## Product Change Notice for EKI-3000 series x 6 models

### End of Life, Last Time Buy and Replacement Announcement

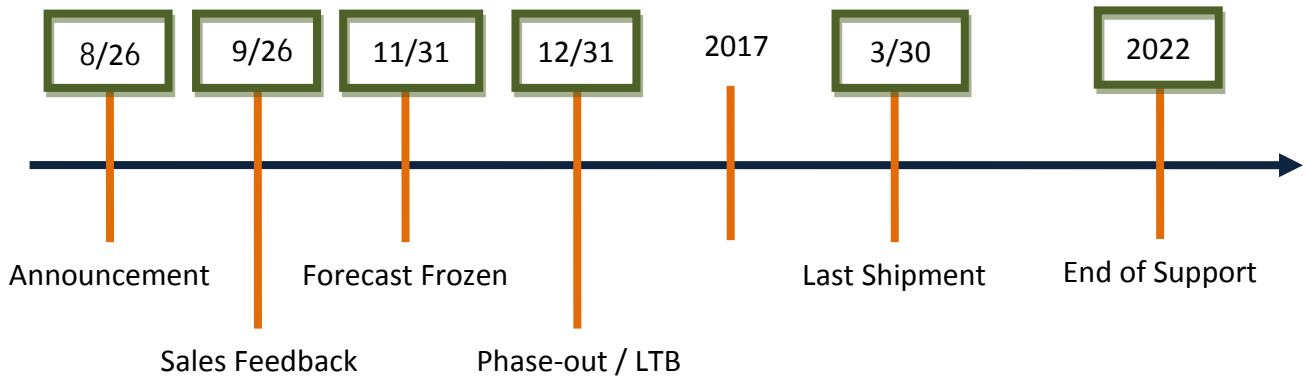
For immediately release, Advantech is announcing the End of Life (EOL) of EKI-3000 series x 6 models. The relative replacing models are EKI-2000 series. Customers who had purchased these Part Numbers either to purchase any additional rules or migrate to the new replacement models if possible before the EOL's shipment date.

- 3<sup>rd</sup> party supply issue of EKI-3000
- Consolidation between EKI-2000 and EKI-3000

End of Life Product	Suggest Replacement Product	Sample Available Date
EKI-3525-AE	EKI-2525-BE	June.01, 2016
EKI-3528-AE	EKI-2528-BE	June.01, 2016
EKI-3725-AE	EKI-2725-CE	July.04, 2016
EKI-3728-AE	EKI-2728-CE	June.01, 2016
EKI-3525M-AE	EKI-2525M-BE	June.01, 2016
EKI-3525S-AE	EKI-2525S-AE	June.01, 2016
